Addendum 48: Regulation No. 49

Revision 5 – Amendment 1

Supplement 4 to the 05 series of amendments - Date of entry into force: 23 June 2011

Uniform provisions concerning the measures to be taken against the emission of gaseous and particulate pollutants from compression-ignition engines for use in vehicles, and the emission of gaseous pollutants from positive-ignition engines fuelled with natural gas or liquefied petroleum gas for use in vehicles

Figure 14
Schematic of Recommended Particle Sampling System – Partial Flow Sampling

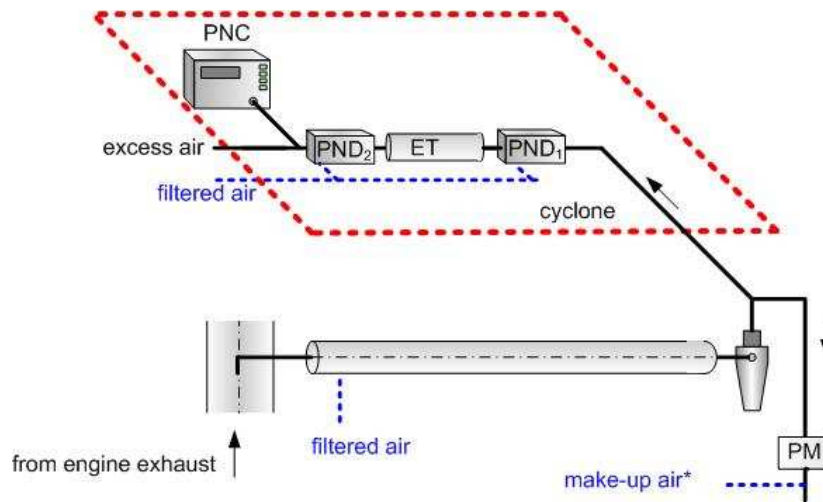
Insert a new Annex 4C and its Appendix 1, to read:

Figures 14 and 15 are schematic drawings of the recommended particle sampling system configures for partial and full flow dilution systems respectively.

* Alternatively, the control software might account for the flow removed by the PN system
